Amendment GC81

Fishermans Bend- Overarching

Expert Urban Design Evidence

March 2018

Draft Fishermans Bend Framework Figure 6

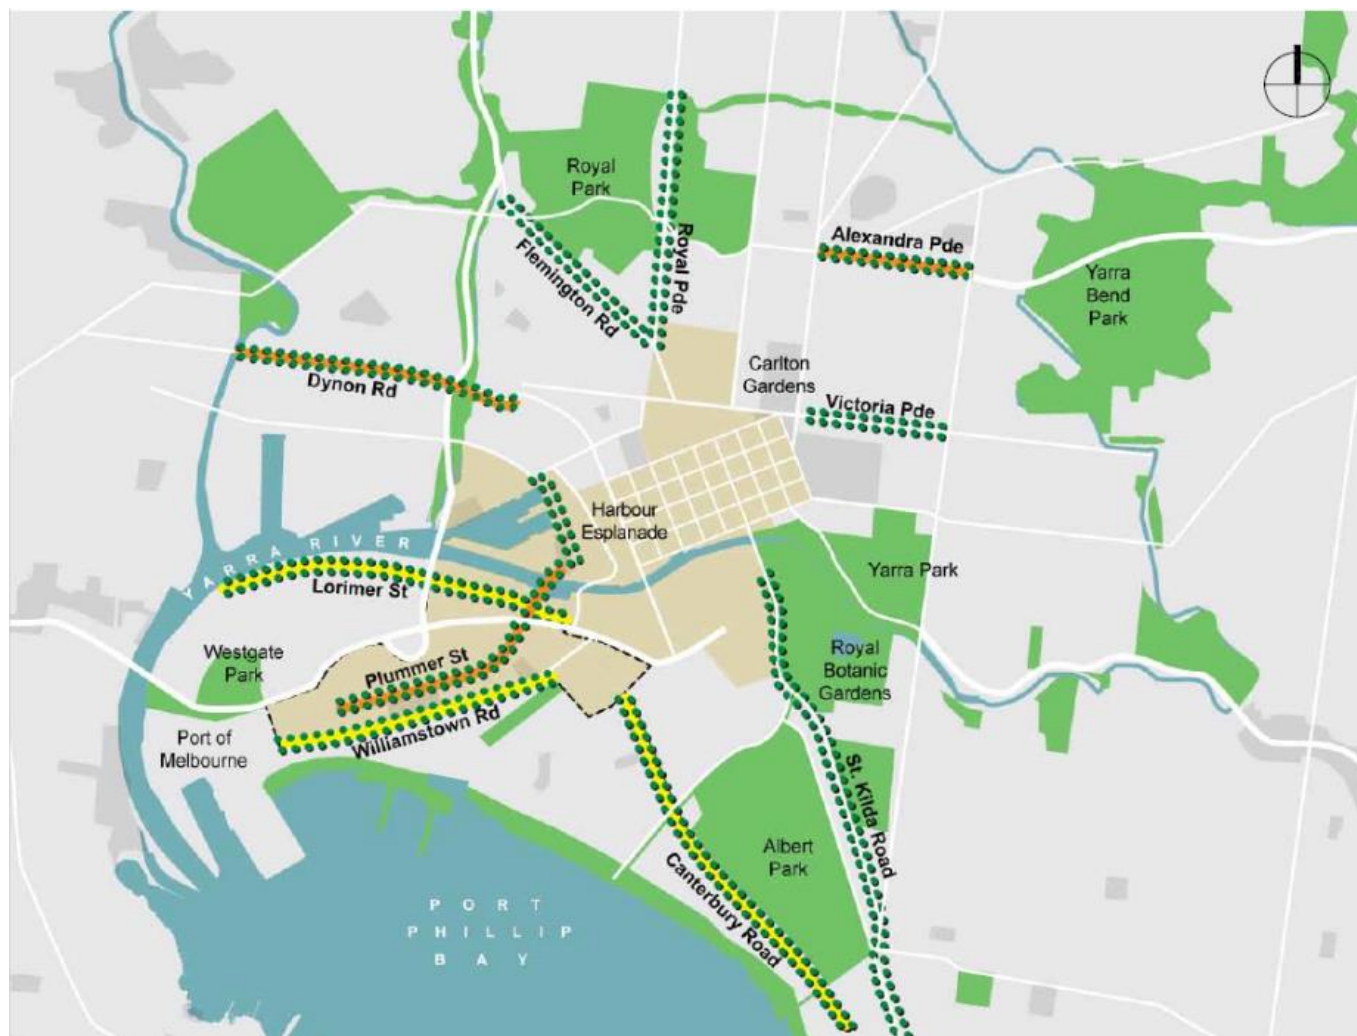
[88] The proposed planning framework identifies a road function hierarchy (see below). However, this is distinct from the primary public transport, pedestrian and cycling hierarchy, which focuses on the civic spines of Turner Street and Plummer/ Fennell Streets, and is identified by wider road reserves, strategic cycle corridors and a prohibition on crossovers.

CCZ Map 1 and DDO Map 2

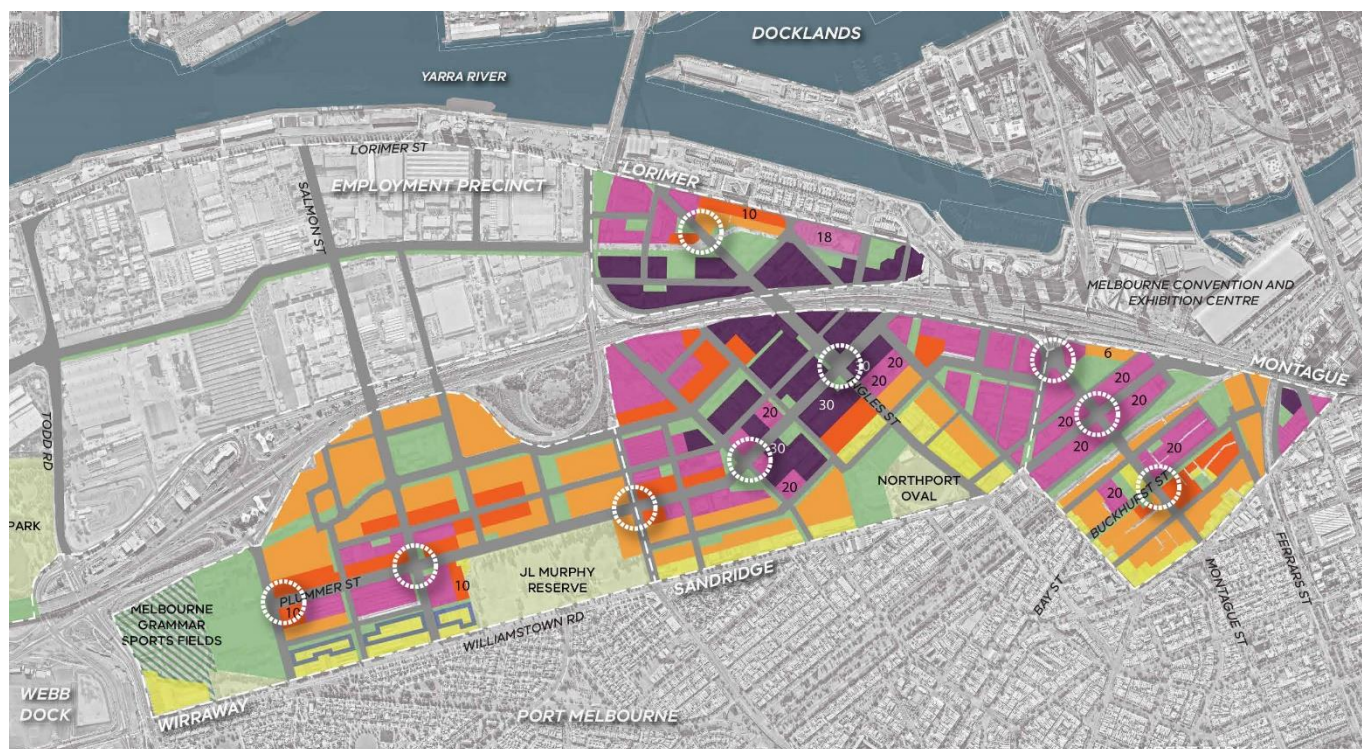
- [104] The relatively small extent of the Montague and, particularly, the Wirraway core from a residential density perspective is exacerbated by the rigid and abrupt nature of the change in density between core and non-core areas. All of the Amendment land will be well served by public transport if the proposed rail and tram routes are built (and, arguably, even if the metro line is not). So it is unclear why the density should drop off so ‘sharply’ one block from Plummer Street, one block south of Fennell Street and about 200m south of the Montague Street light rail stop—or, indeed, in the section of Plummer Street between the Wirraway and Sandridge cores. All of these areas will still be very well served by public transport as shown below.

- [106] Although it is common for activity centres to incorporate higher residential densities, it is also common for them to be surrounded by higher residential densities, rather than the residential density dropping off immediately at the edge of the activity centre. Indeed, this is encouraged by State planning policy at clause 11.03-2.

Urban Design Strategy Figure 42

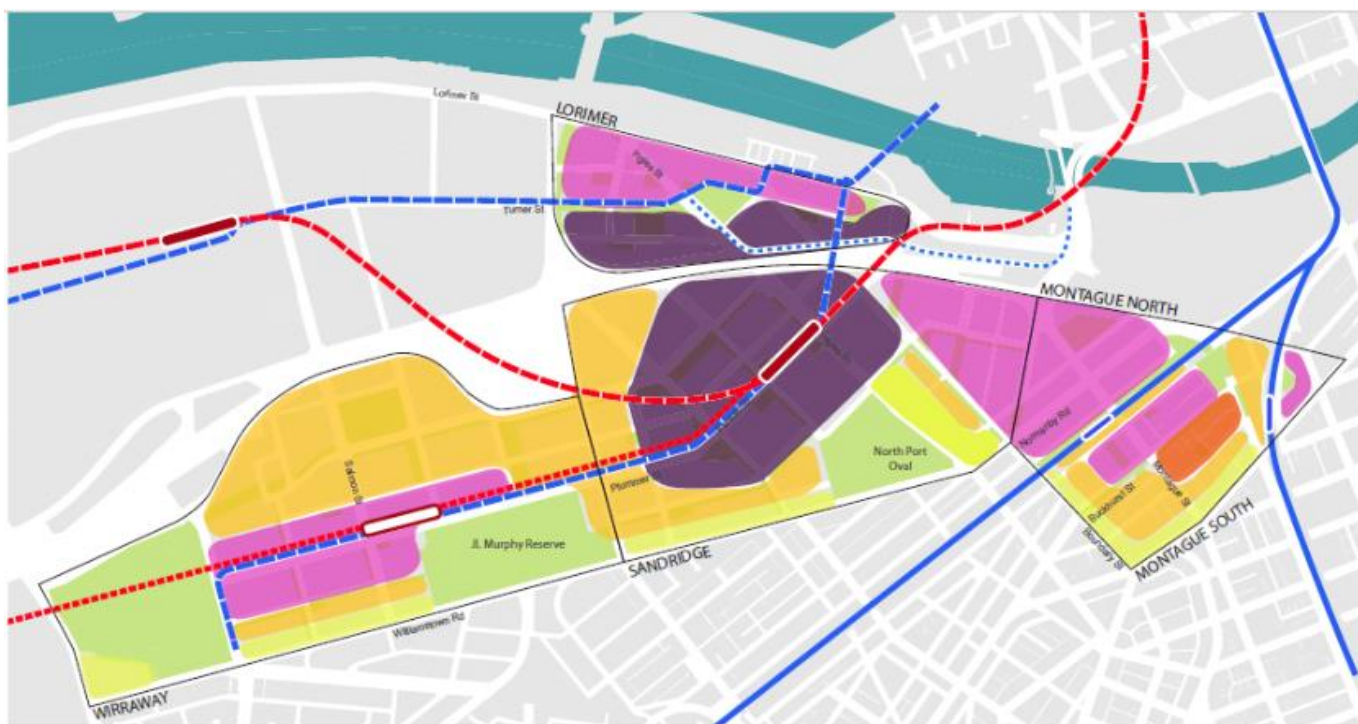
Street (and even fronting Plummer Street either side of Graham Street). This is not a comment on the built form principle of stepping down towards Garden City, south of Williamstown Road, which I discuss below.

- [288] It is entirely possible to conceive of built form character types that would be distinct from the podium-tower areas and create high quality places while also providing for more growth than what is proposed. For example, DLA's investigation into alternative higher-density built form models (see Appendix E) demonstrates that the 'Barcelona' model delivers a significantly increased density (up to an FAR of approximately 4:1—almost twice that proposed in the non-core area of Wirraway) within a height of 7 storeys, while providing 'family-friendly housing'.

Section through southern edge on Williamstown Road

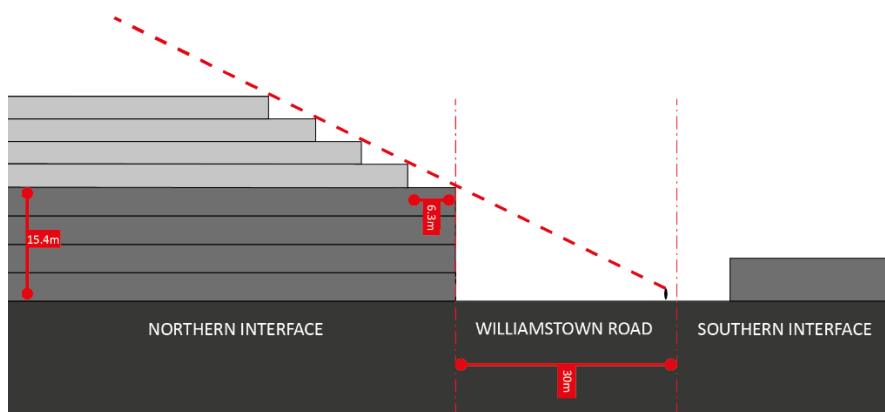
- [298] This demonstrates that the proposed mandatory 4-storey height on Williamstown Road would unnecessarily limit the provision for growth on properties along its north side. The requirement need not be mandatory to achieve the outcome of a transition—or, it need not be mandatory for anywhere near the depth proposed.
- [299] Therefore, I recommend that the mandatory 4-storey maximum building height be replaced with 4-storey maximum street wall height and a requirement for a 10m (and the 'underlying' maximum height to the north be applied). This will ensure that any additional levels are sufficiently set back to avoid any unreasonably visual impact on the south side of Williamstown Road. This is illustrated below.
